A G E N D A

Architectural Review Board

May 23, 2017

STREET ELEVATION (SOUTH)
1/4" = 1'-0"

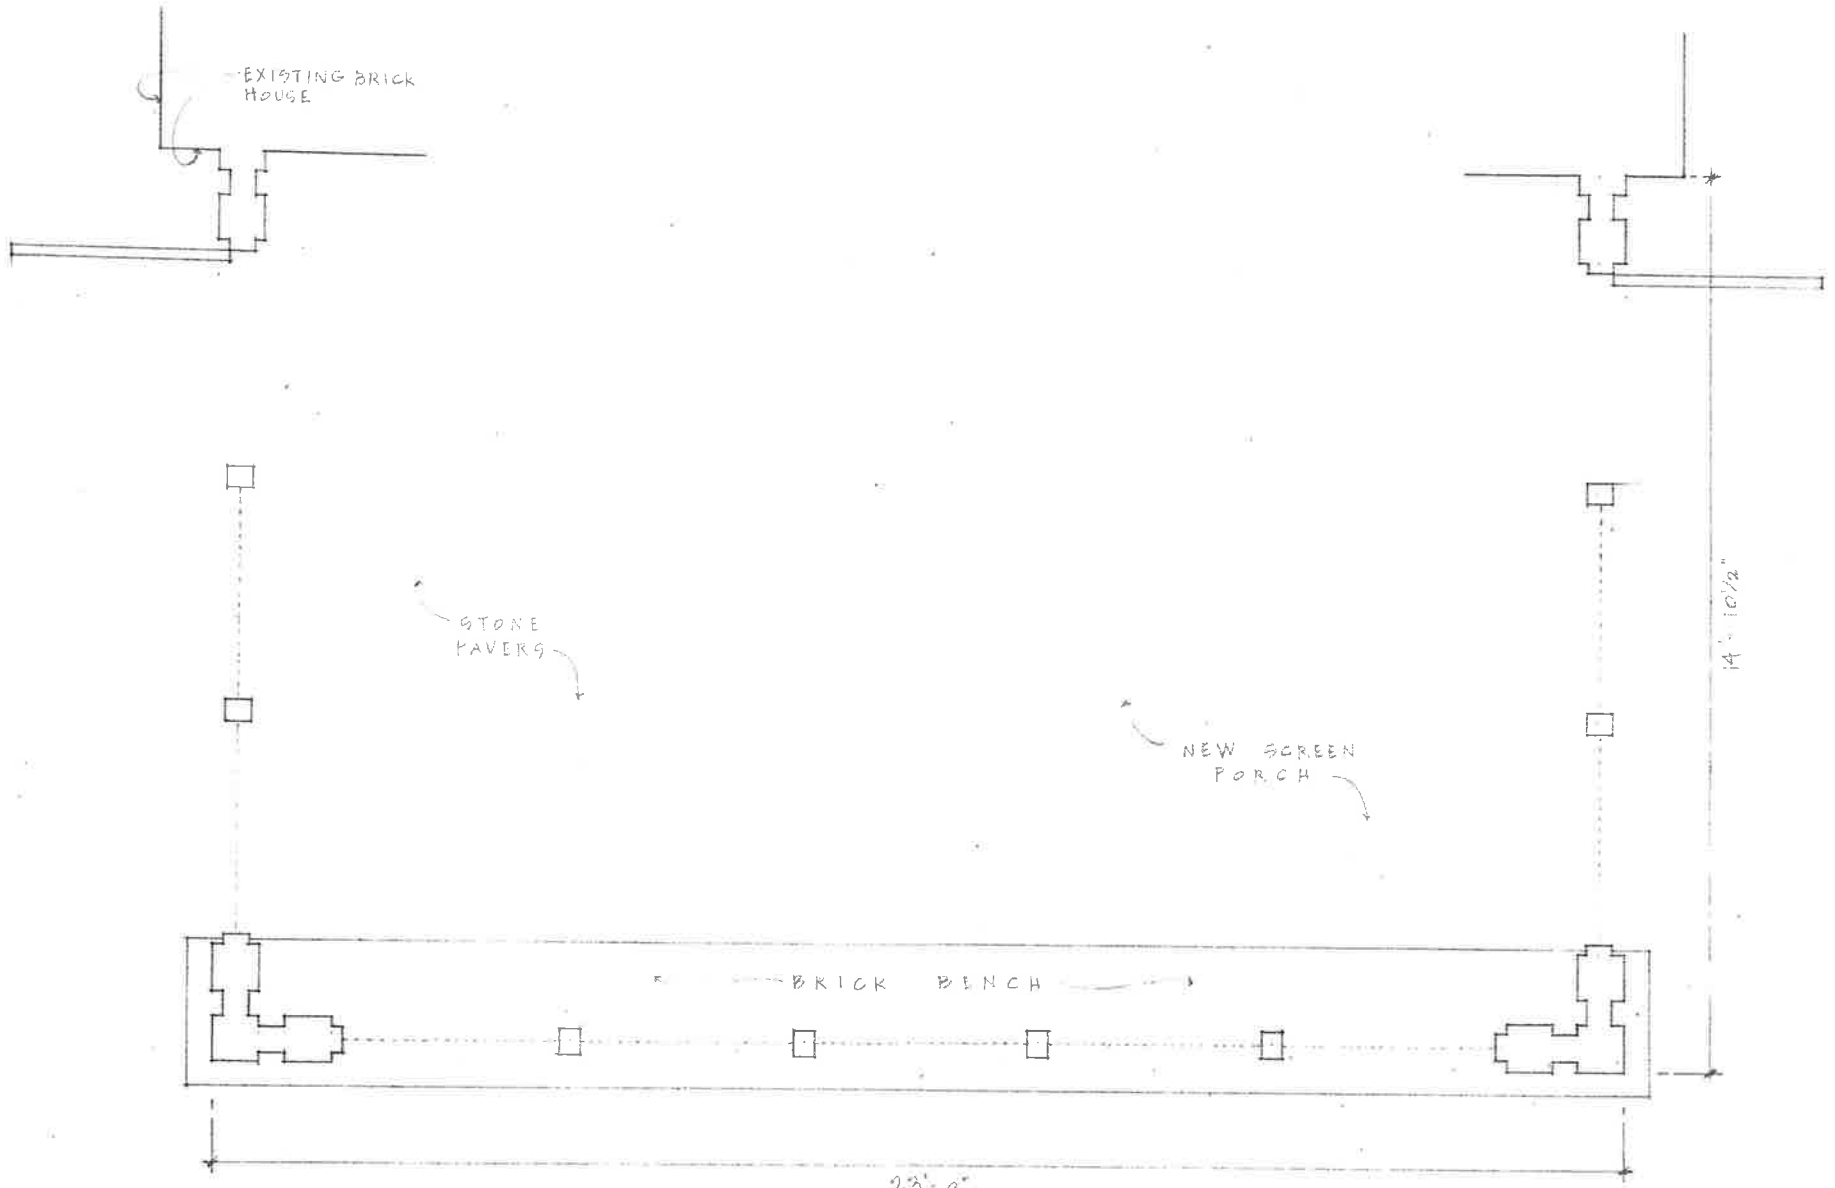
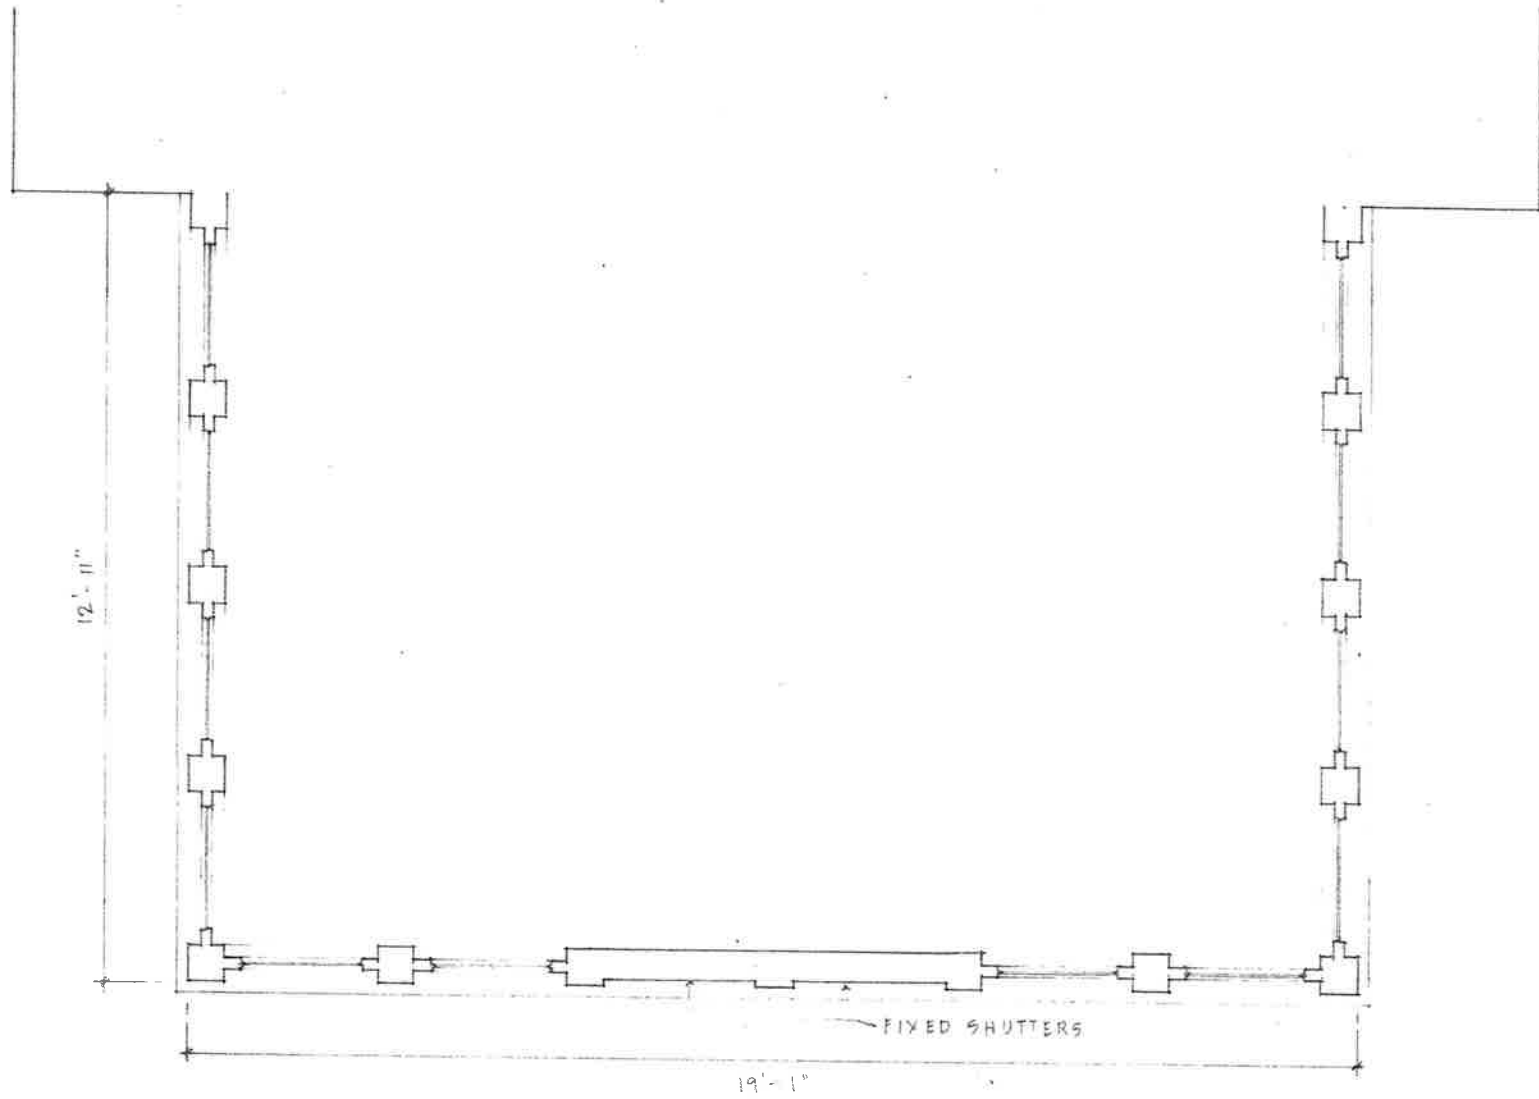
This item was carried over to the May meeting at the request of the Board to allow additional documentation to be compiled. The Board requested the owner consider using a conventional foundation instead of a slab as it would inflict less damage to the root system of a nearby large tree, and requested that the location of the tree be marked on a site plan in relation to the addition.

- No comment, as a foundation plan was not submitted before the agenda was completed.

704 Felder Avenue

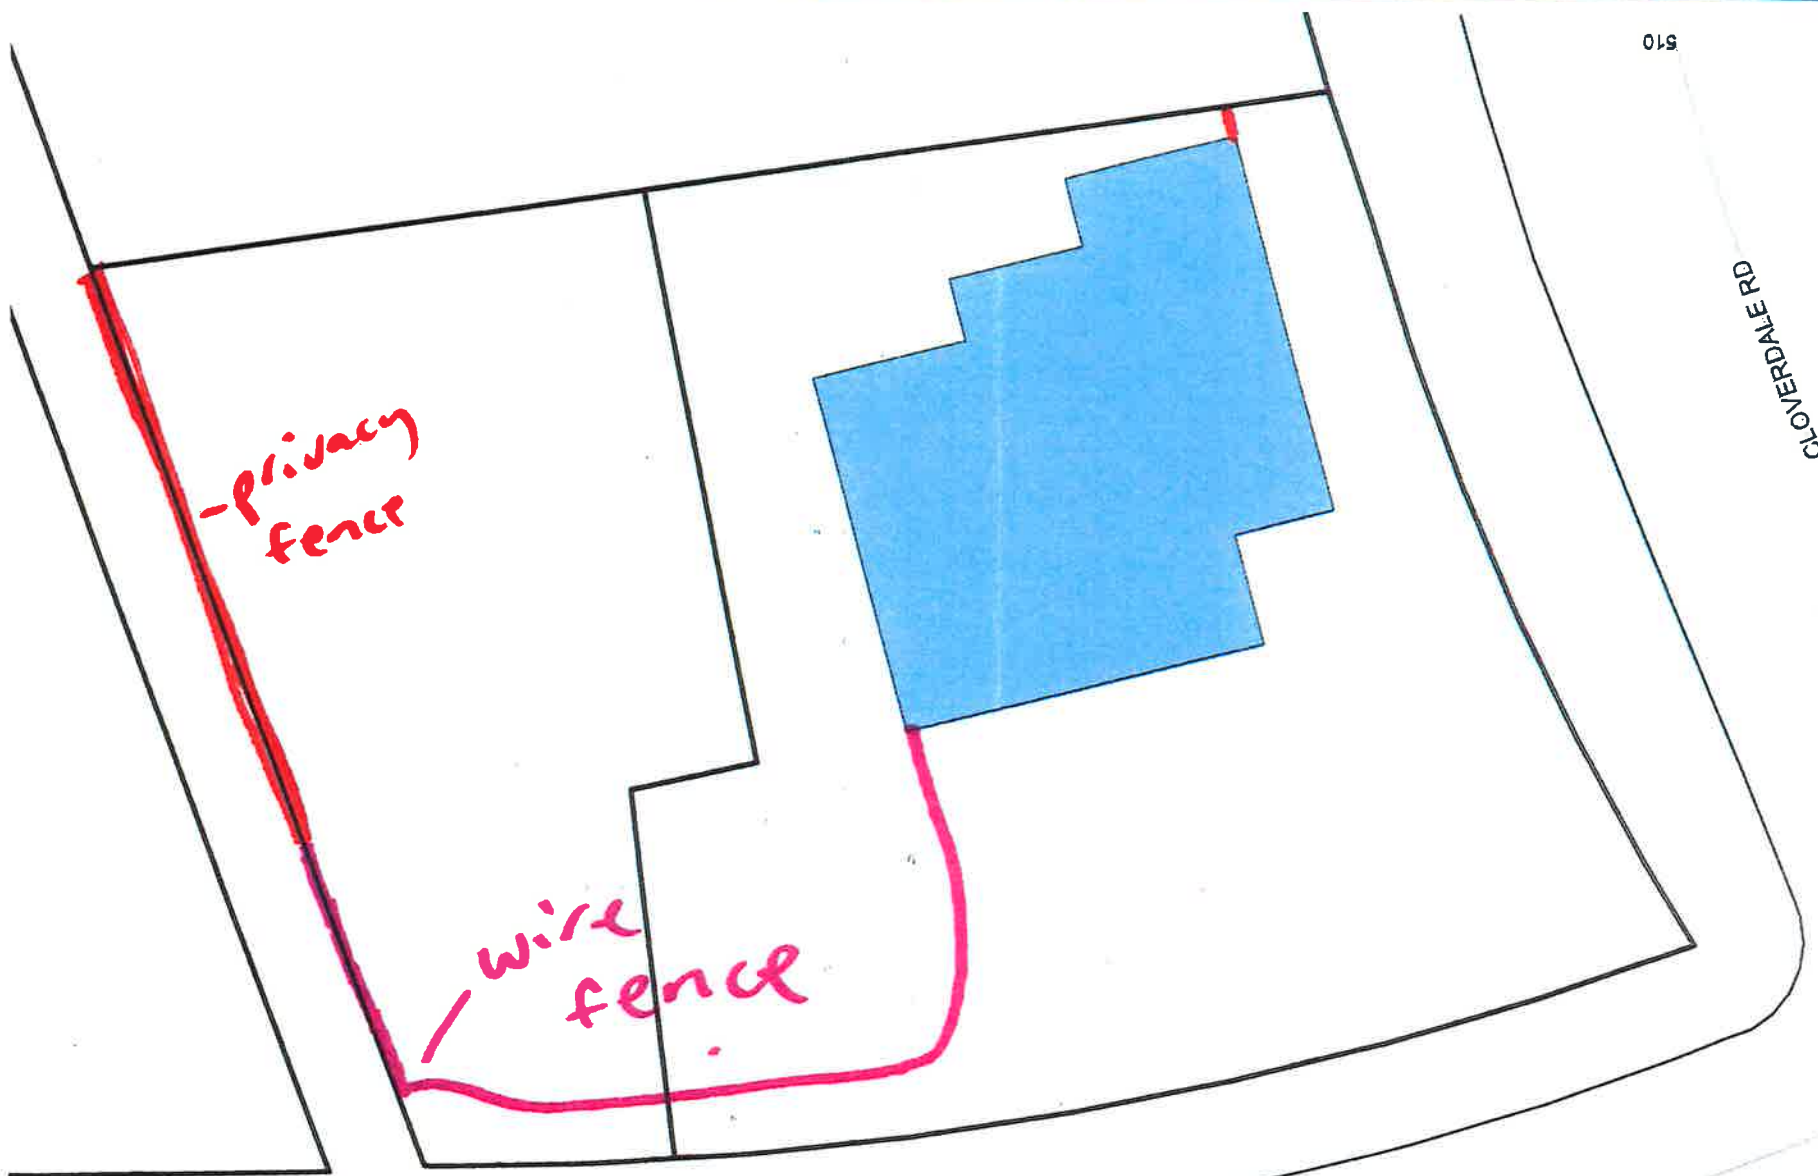
- At the April meeting, staff requested feedback from the Board regarding a tall picket fence design, the Board recommended that the petitioner consider a fence material that would disappear behind the vegetation instead, as picket fences would not have traditionally been taller than 3'-4'.
- The existing vegetation will screen the fence from the Felder frontage. The privacy fence would start approximately in line with the front building line, which would leave to view open to the front porch on the east as well, maintaining the visual site line down the street from the "front porch" view.

Site Plan

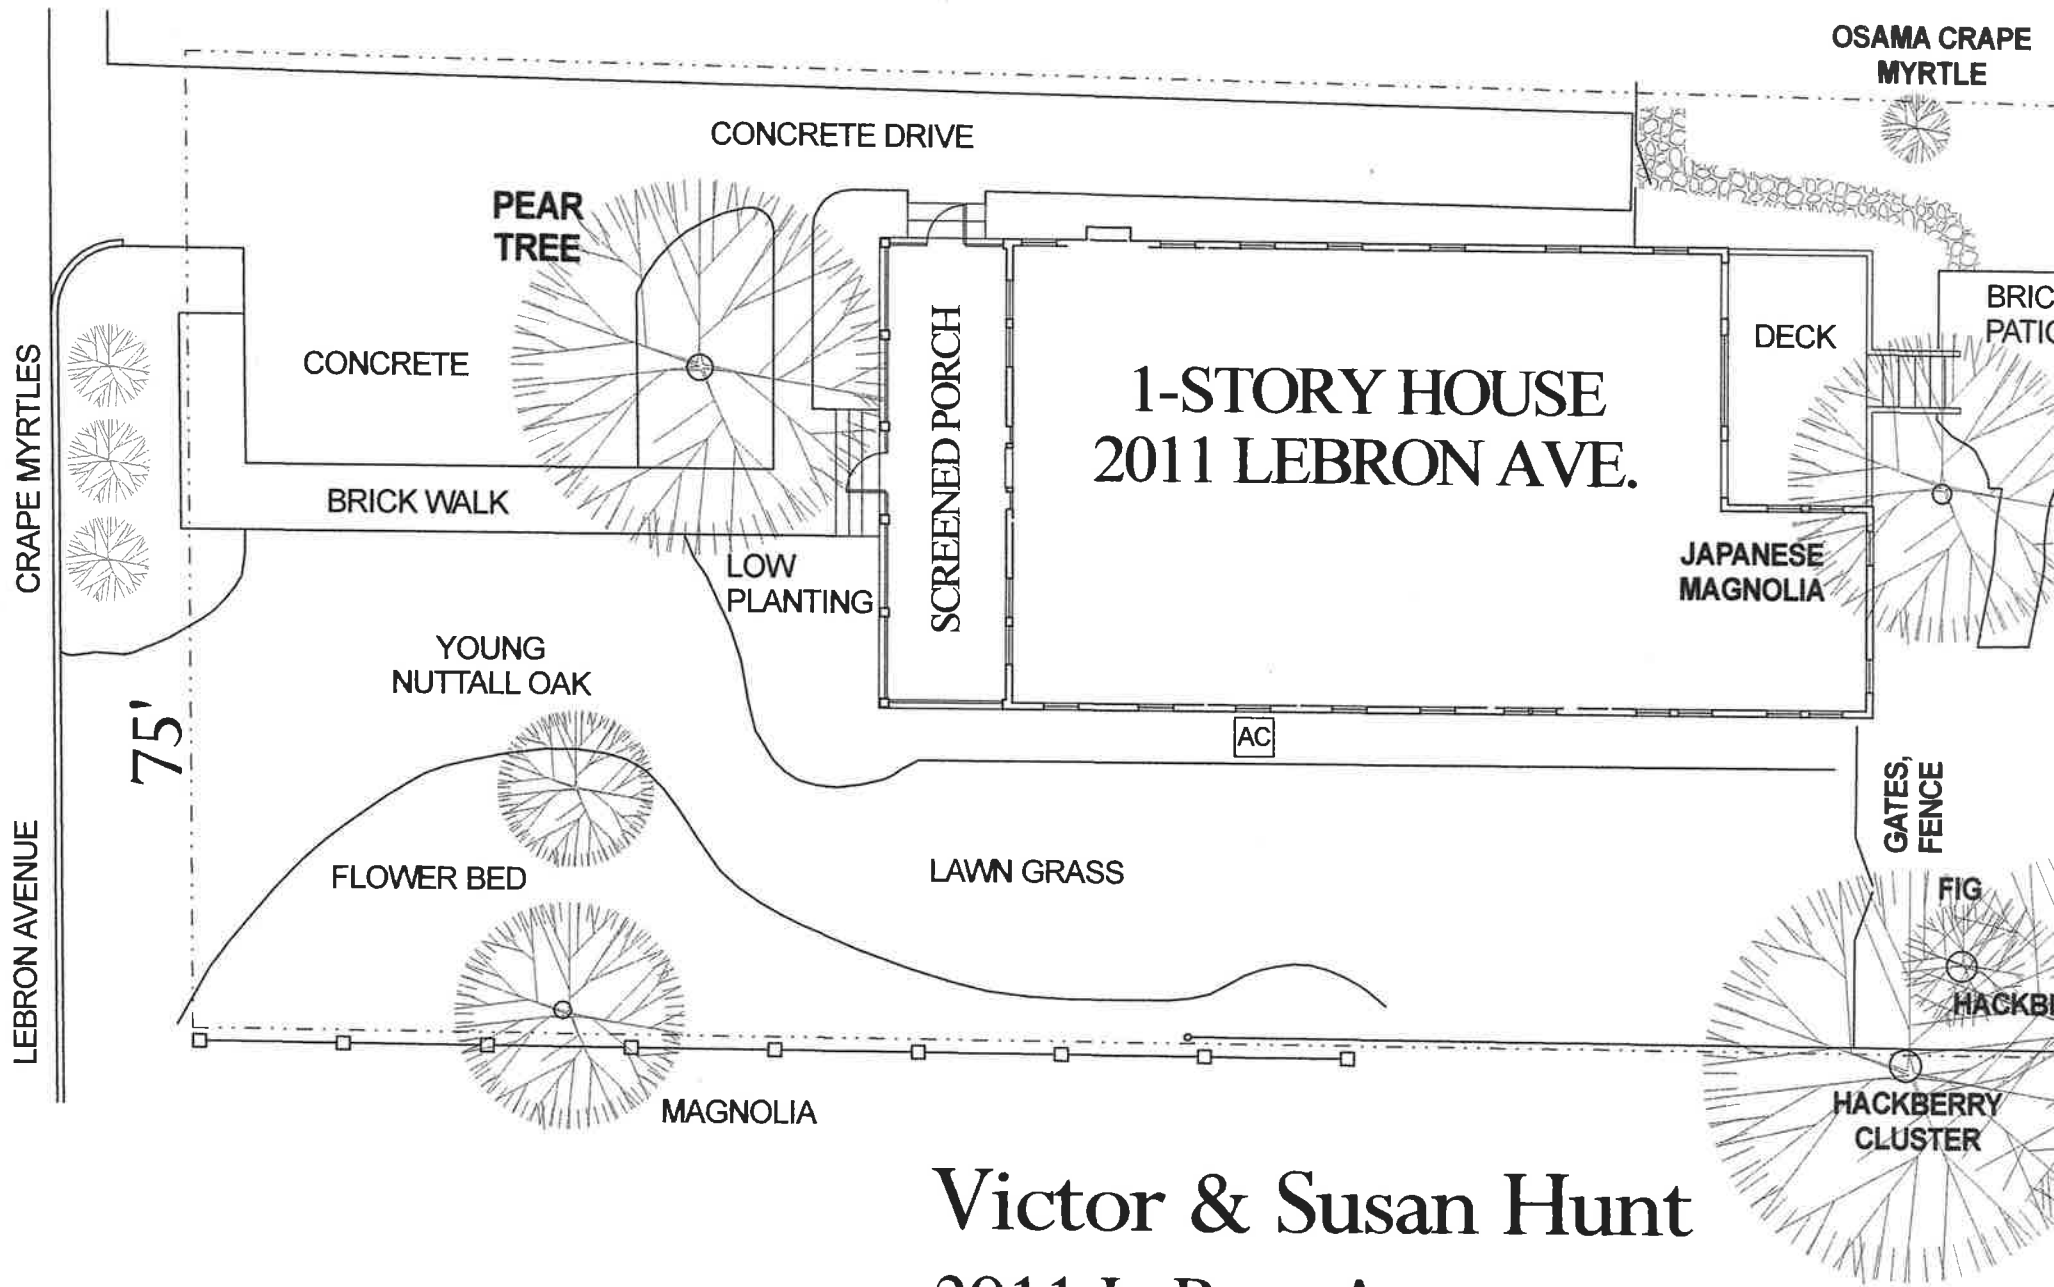
REMARKS: The petitioner is requesting permission to remove an ornamental pear tree from the front of the house that was planted close to the front porch. The tree hangs over the house, drops “marbles” and staining red fruit that have caused slips and affected paint finishes, and the roots have heaved the brick walkway. The petitioner would like to select a different ornamental tree to replace it.

- Urban Forester recommends removal and replacement with a less invasive species.
